HOUSTON LIGHTING & POWER COMPANY  
ALLENS CREEK NUCLEAR GENERATING STATION - UNIT NO. 1  
PRELIMINARY SAFETY ANALYSIS REPORT  
AMENDMENT NO. 59  
INSTRUCTION SHEET

This amendment contains information pertaining to the PSAR Update. Each revised page bears the notation Am. No. 59, (6/81) at the bottom of the page. Vertical bars with the number 59 representing Amendment No. 59 have been used in the margins of the revised pages to indicate the location of the revision on the page.

ENLARGED PLOT PLAN  
FIGURE 1.2-3

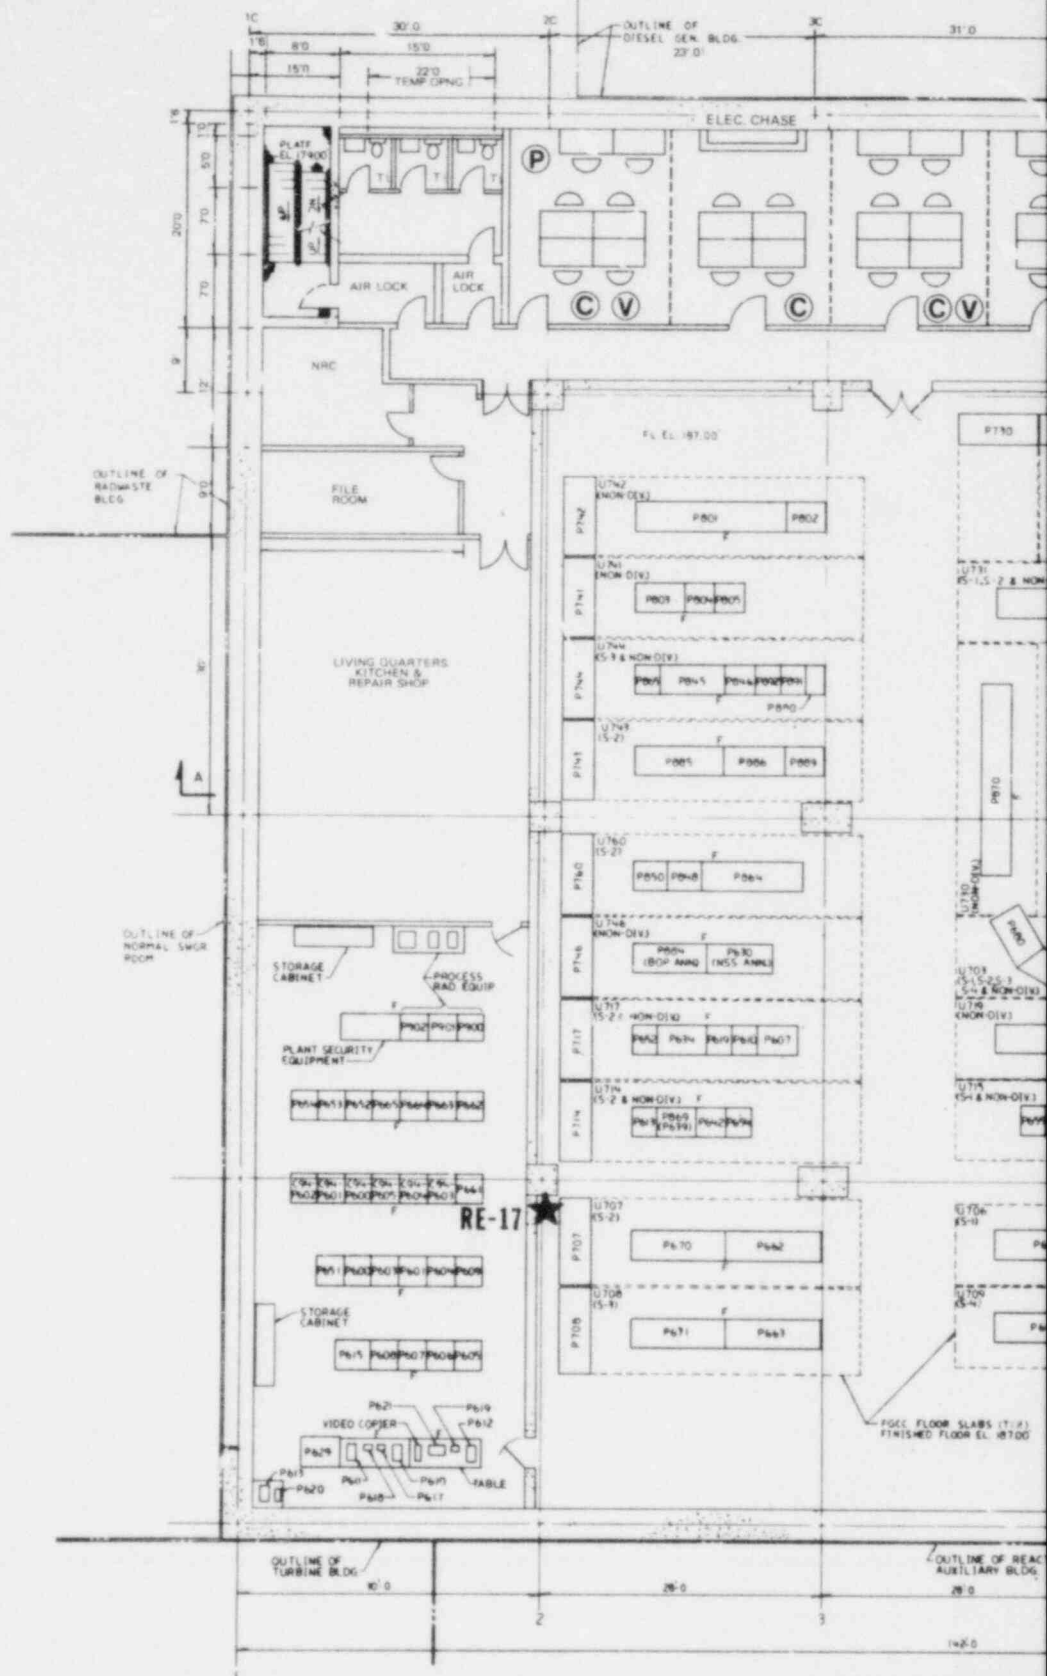
The TSC is located on the northeast side of the Control Building at el.187', as shown on Figure 1.2-3. Walking time between the TSC and Control Room is well under two minutes. The two areas and the hall between them are in the same ventilation envelope as described in Section 13.3.5.2.6, so there would be no need to don protective gear to pass from one area to the other. There are no major security barriers between the two areas.

GENERAL ARRANGEMENT - CONTROL  
BLDG. PLAN AT EL. 187.00'

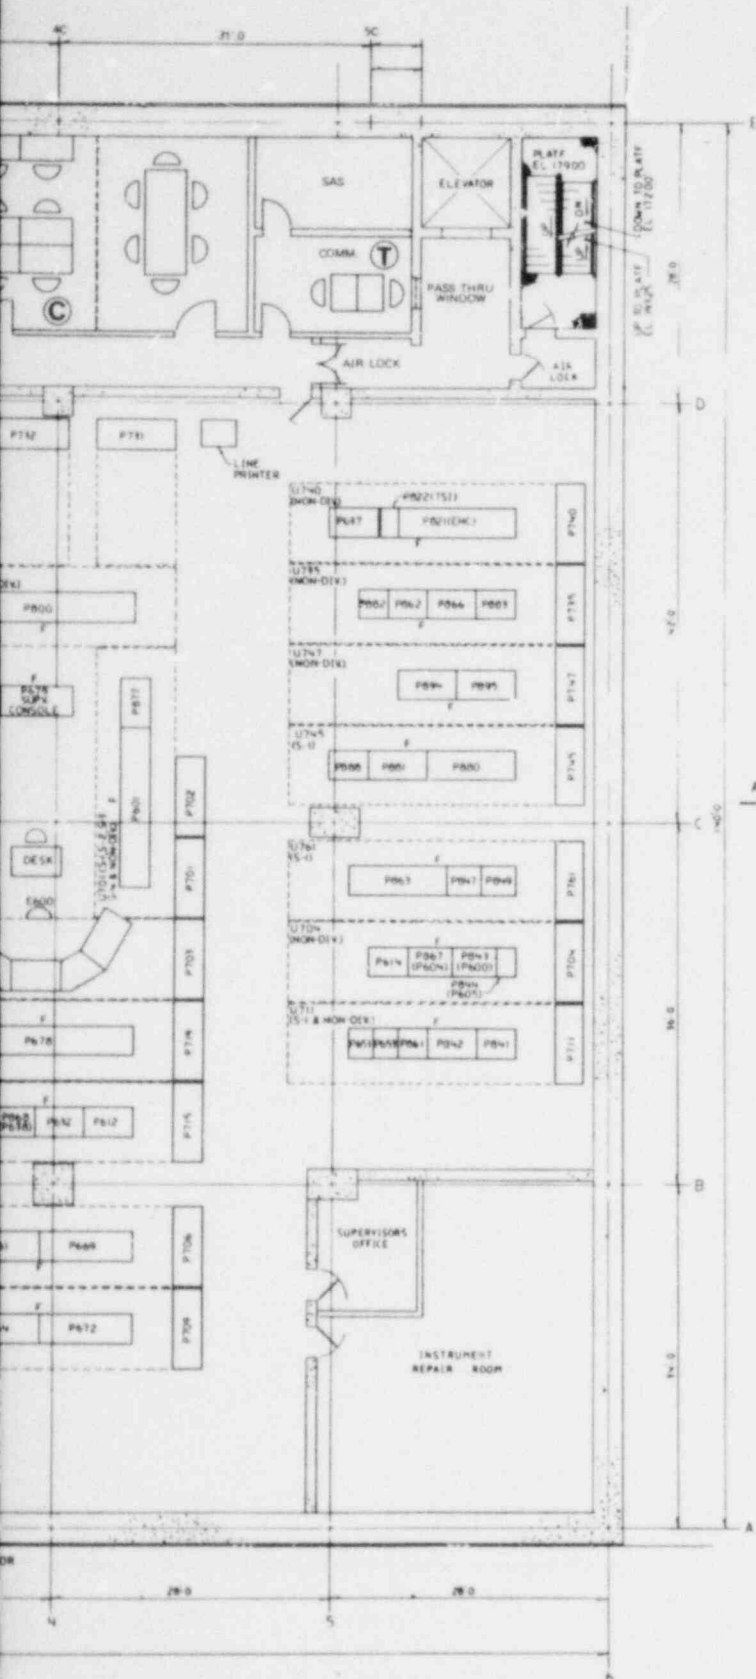
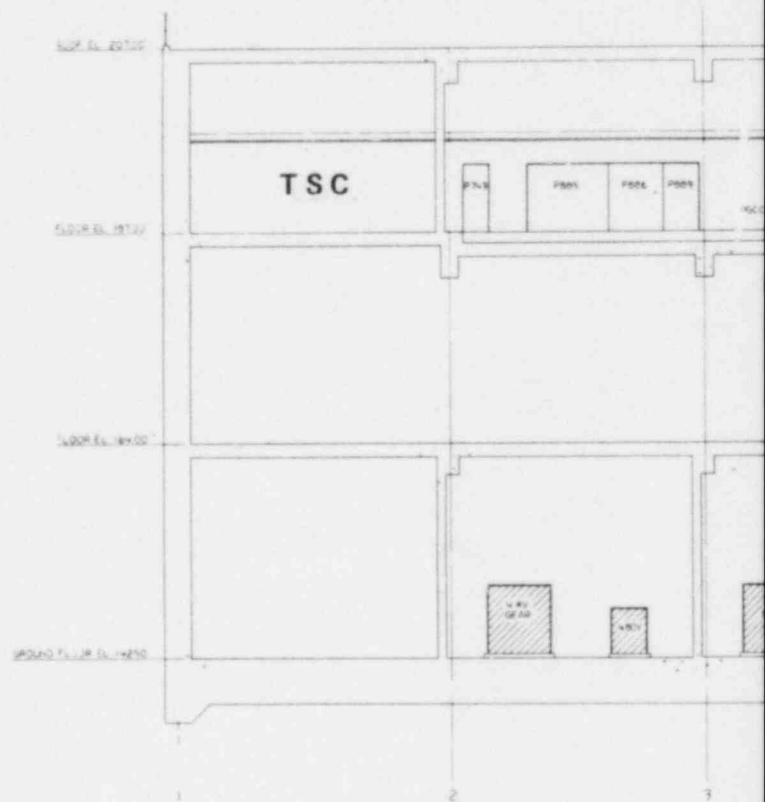
NOTE: FIG. 1.2-33 MODIFIED TO SHOW PROPOSED LOCATION OF TSC

GENERAL ARRANGEMENT  
 CONTROL BUILDING  
 SECTION A-A  
 FIGURE 1.2-35

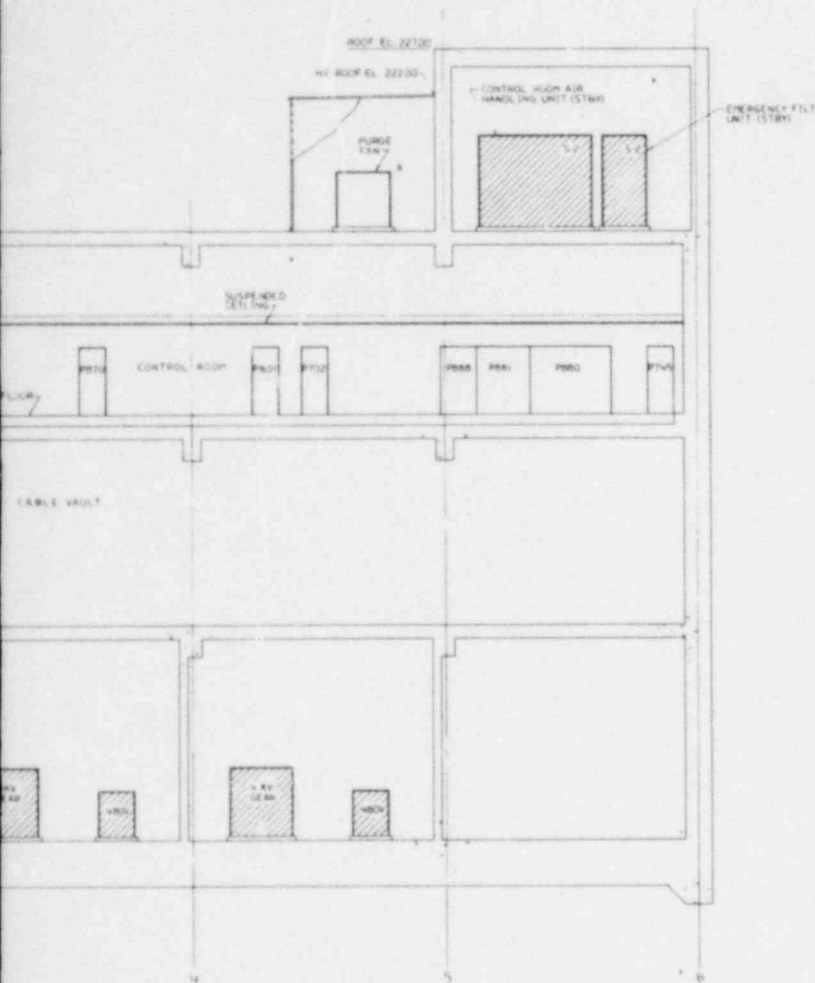
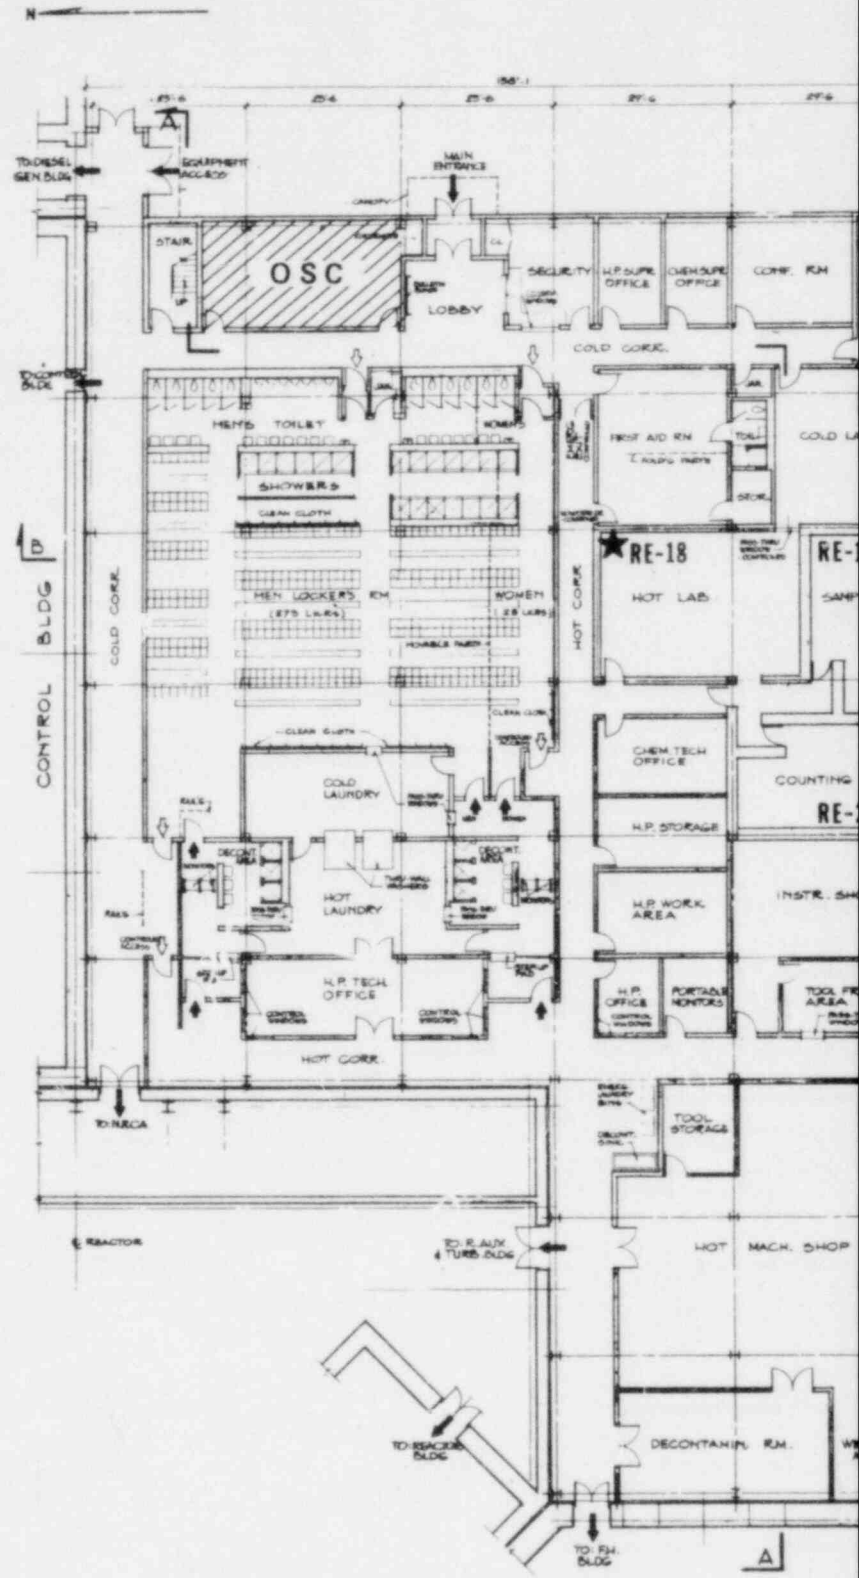
NOTE: FIG. 1.2-35 MODIFIED TO SHOW PROPOSED LOCATION OF TSC.

GENERAL ARRANGEMENT  
PERSONNEL ACCESS BUILDING  
FLOOR PLANS  
FIGURE 1.2-38a

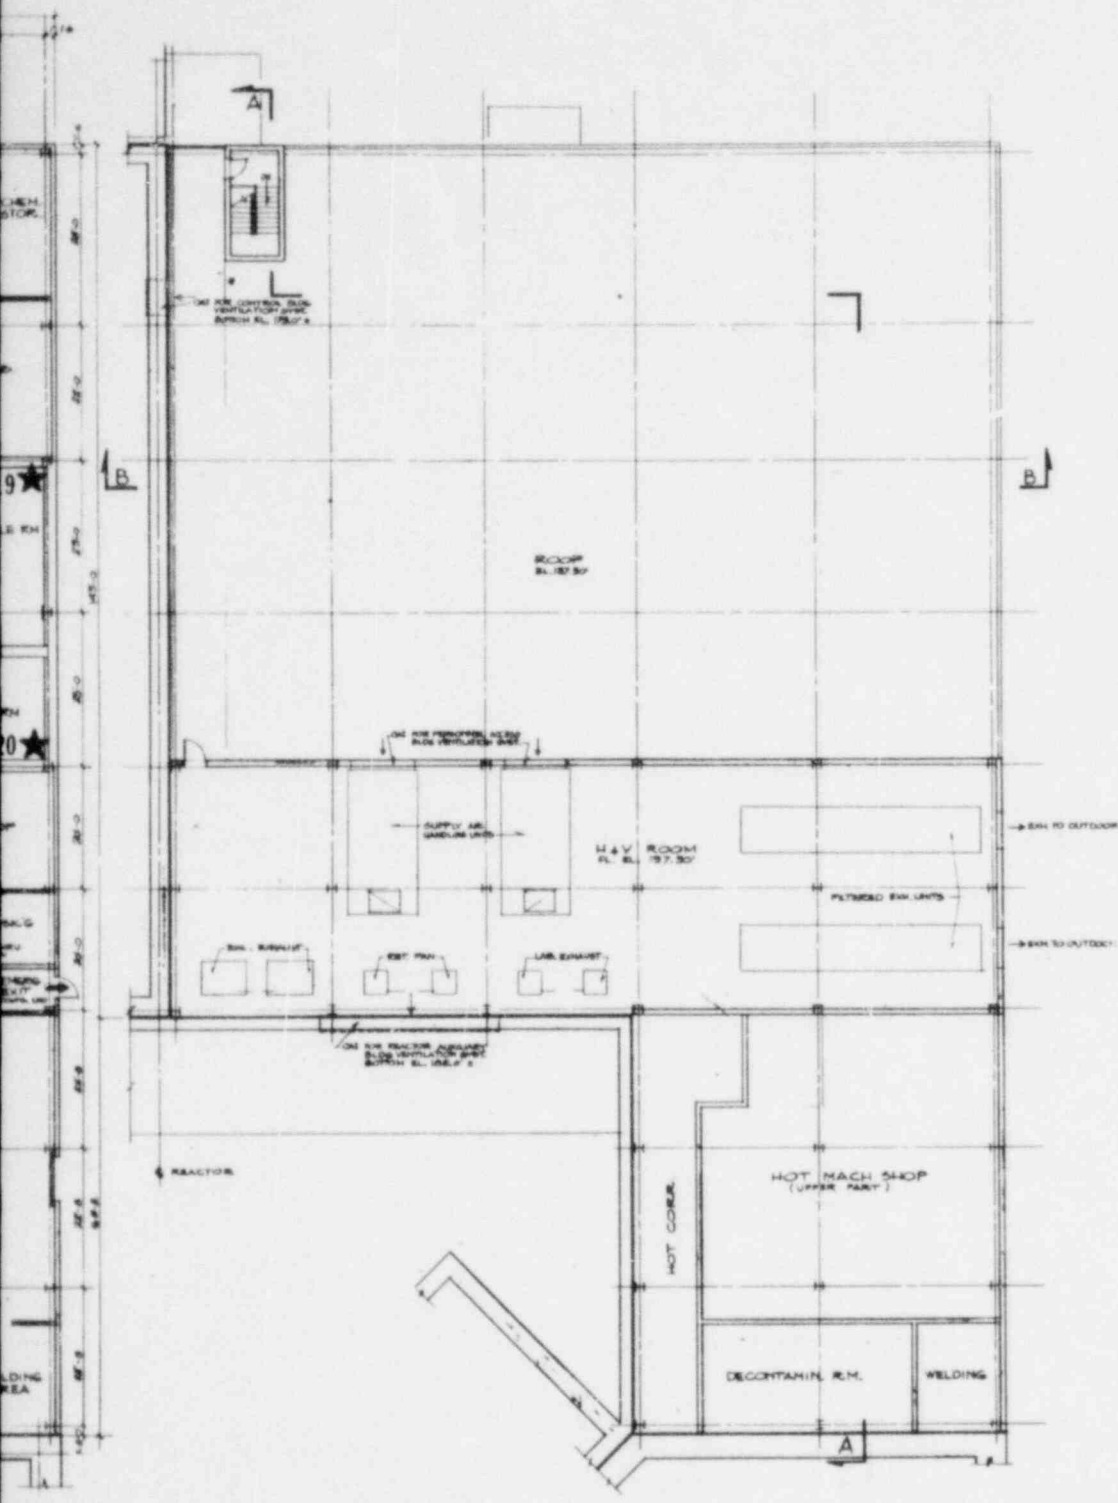
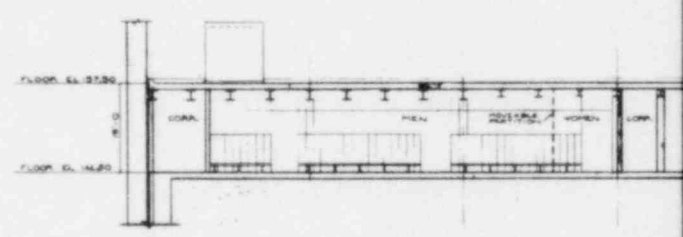
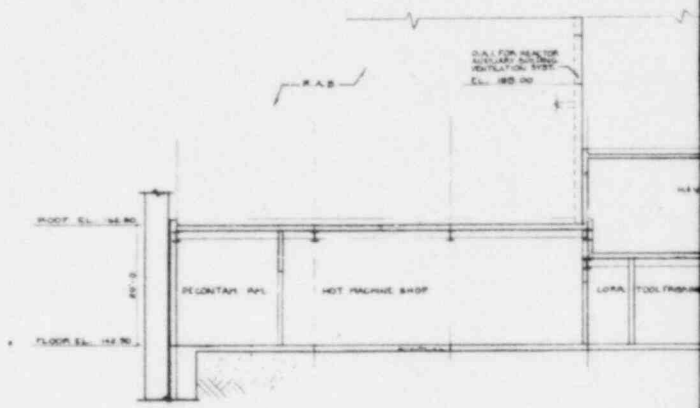
NOTE: FIG. 1.2-38a MODIFIED TO SHOW PROPOSED LOCATION OF OSC.
